New Bus Garage – Washington County Schools
Springfield, Kentucky
BG #19-367

ADDENDUM NO. 1
November 25, 2020

SHEET **E201**
DATE: Sept 28, 2020
JOB#: 1924
DRAWN: WT
CHECKED: WT

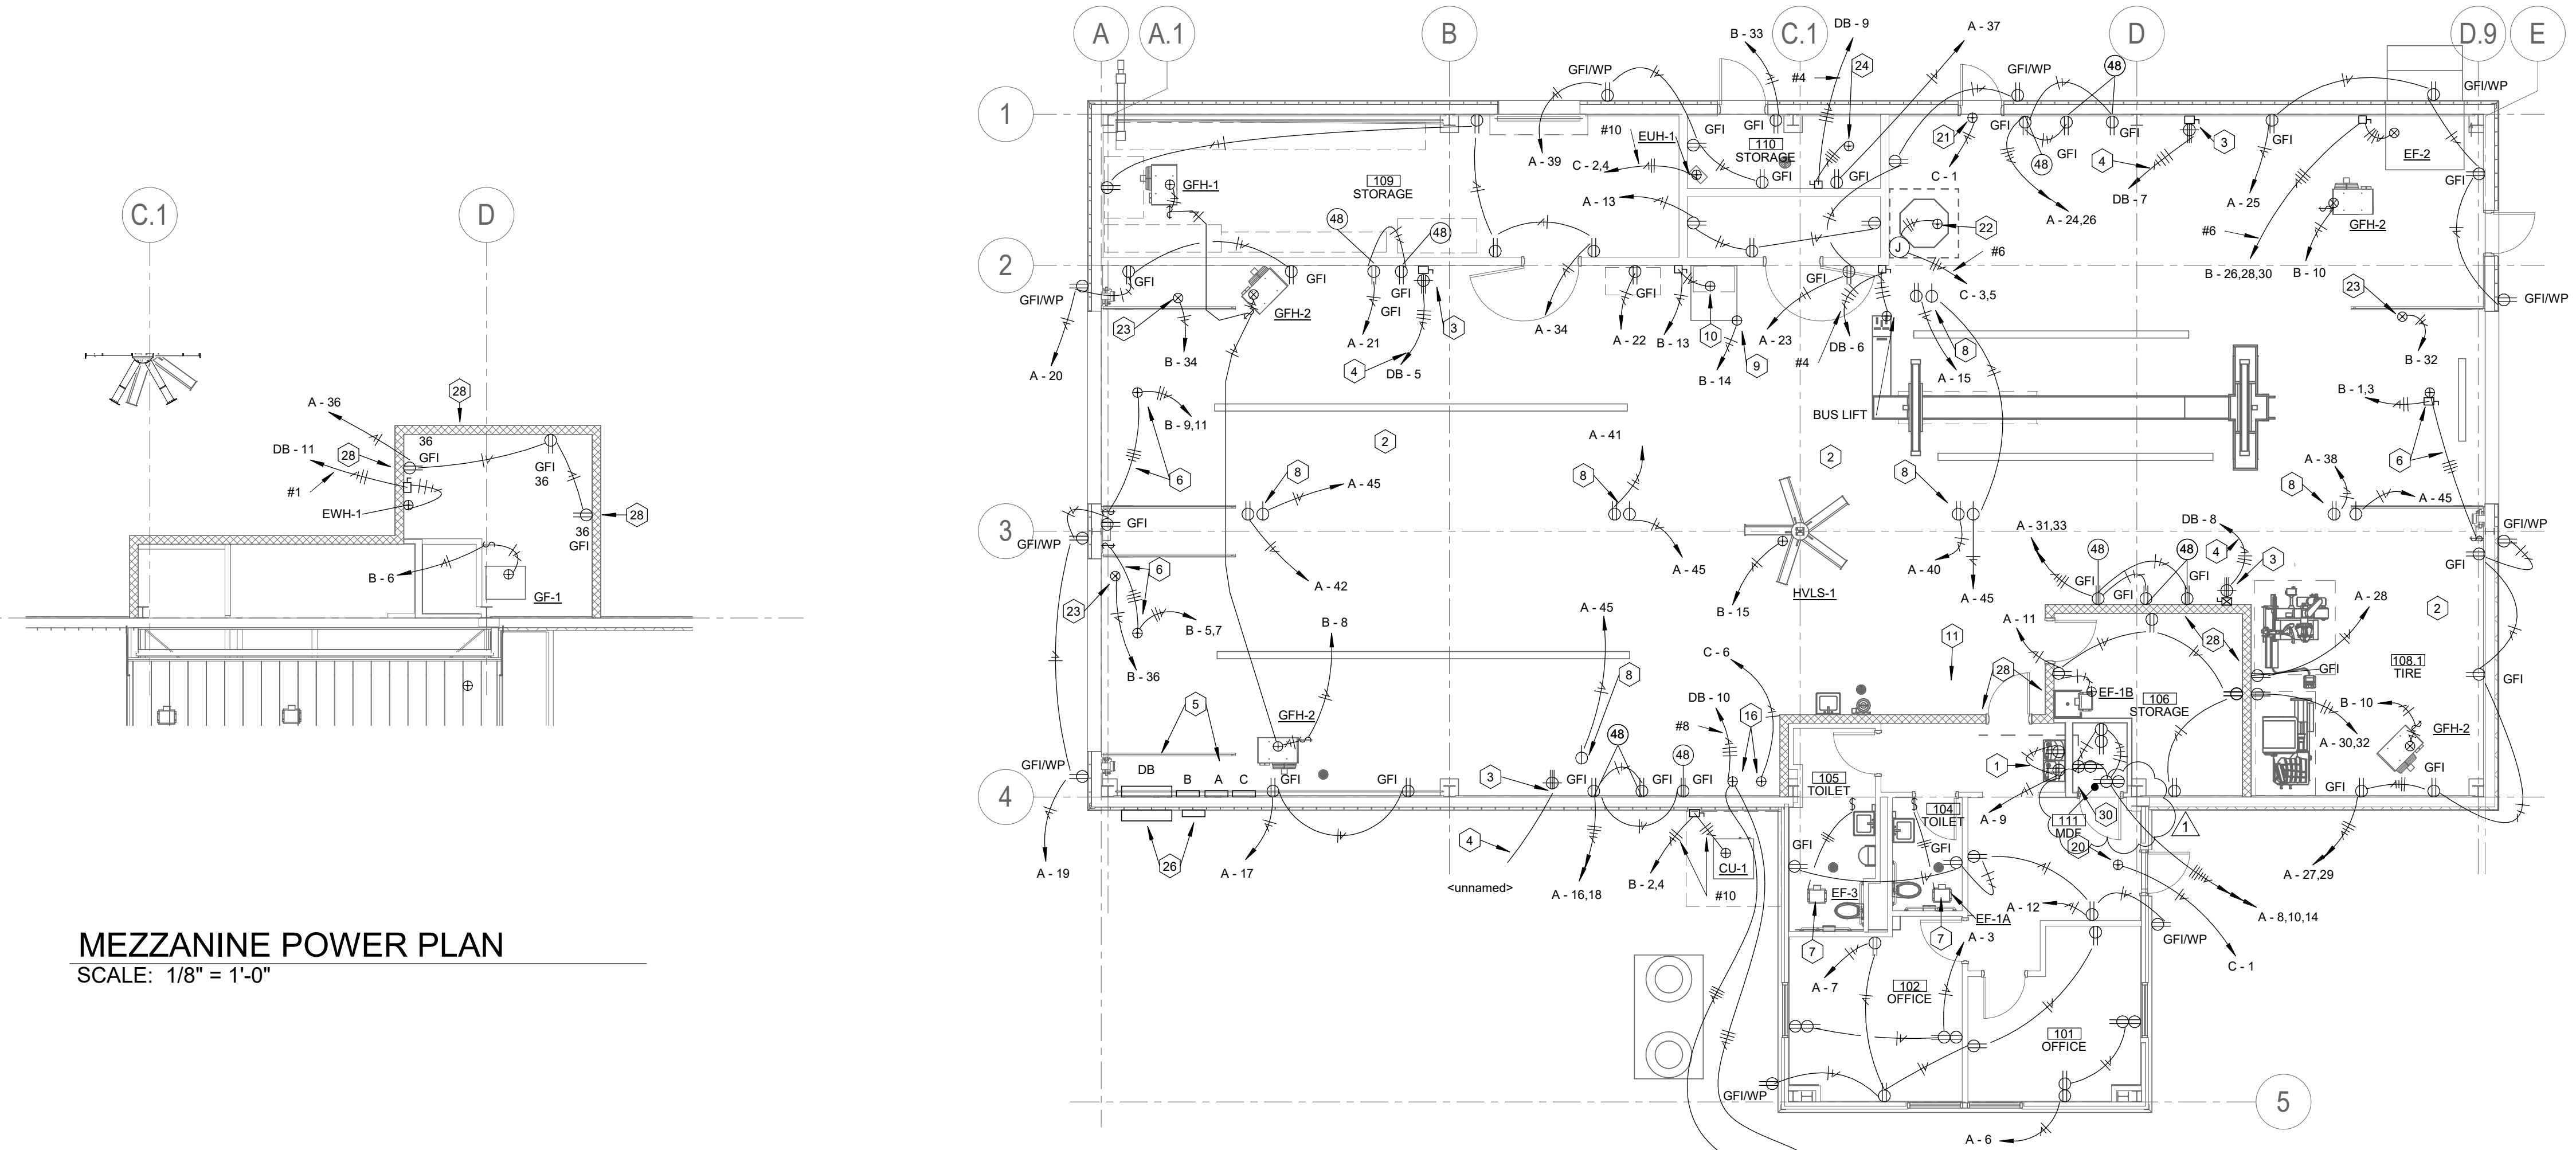
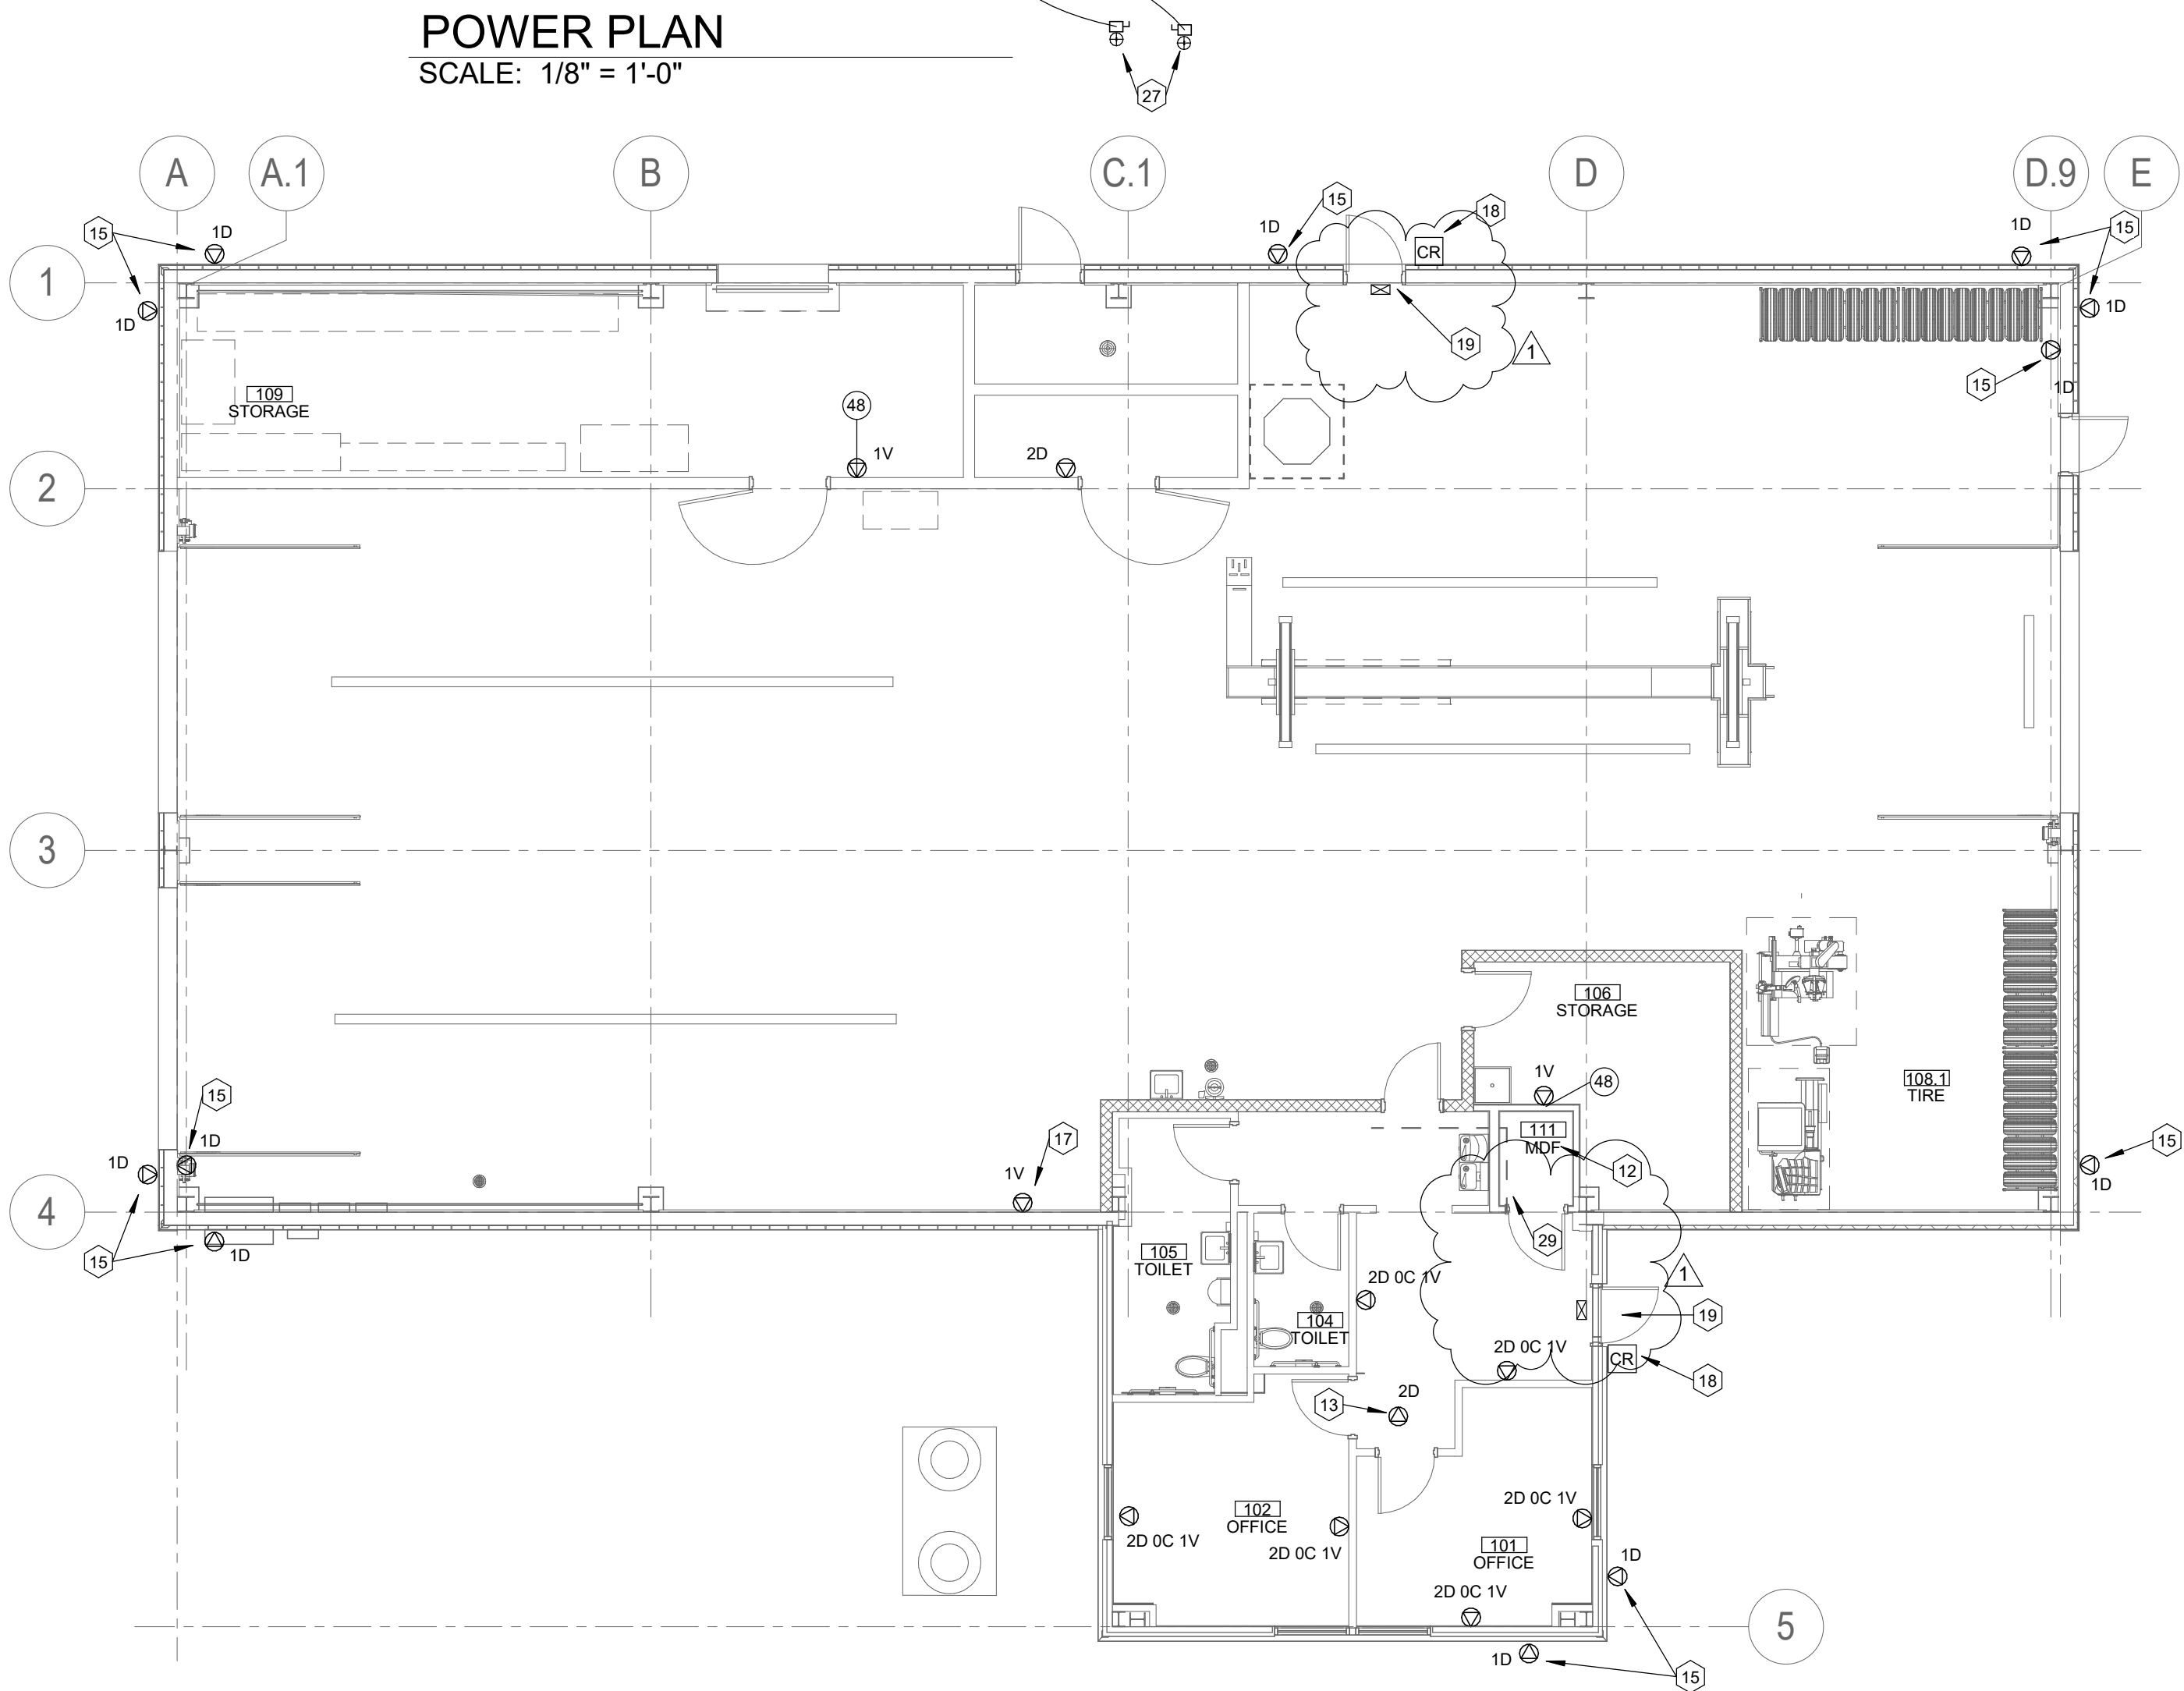
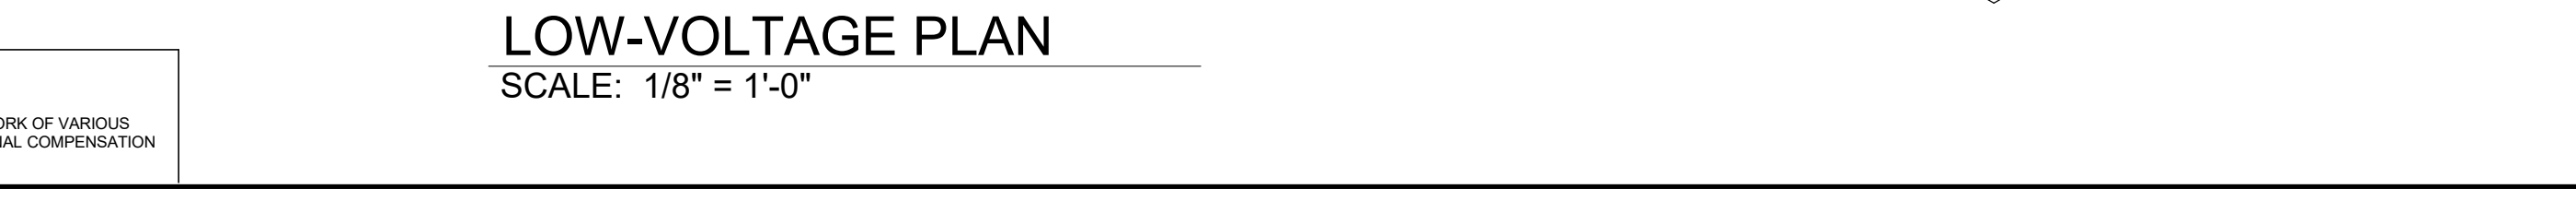
- iv. OLF-3, 3A, 4 – Hubbell
15. Sheet E201: E201 Refer to the attached, revised sheet E201 R2 – Power and Low-Voltage Plans: The door access control system controller, cabling, card readers, and programming is to be provided by the Contractor. Coordinate with the door hardware specifications. System is to connect to the Washington County Schools’ District-wide Video Insight MultiCast access control system. Provide complete and functional system

- ALL BOXES AND CONDUIT ON BOTH SIDES OF THREE-HOUR RATED FIRE WALL SHALL BE SURFACE MOUNTED.
- PROVIDE AND INSTALL ONE VIDEO INSIGHT MULTICAST #P1502 DUAL CARD READER/DUAL DOOR ACCESS CONTROL PANEL TO CONTROL TWO DOORS. PROVIDE ETHERNET CONNECTION TO CONTROLLER. PROVIDE PROGRAMMING OF SYSTEM TO CONTROL TWO DOORS AND CONNECT TO OWNER'S REMOTE MULTICAST SERVER. COORDINATE WITH DOOR HARDWARE SPECIFICATIONS.

- PROVIDE 120V CONNECTION TO DOOR ACCESS CONTROL SYSTEM CONTROL PANEL. CONNECT TO CIRCUIT A-8.
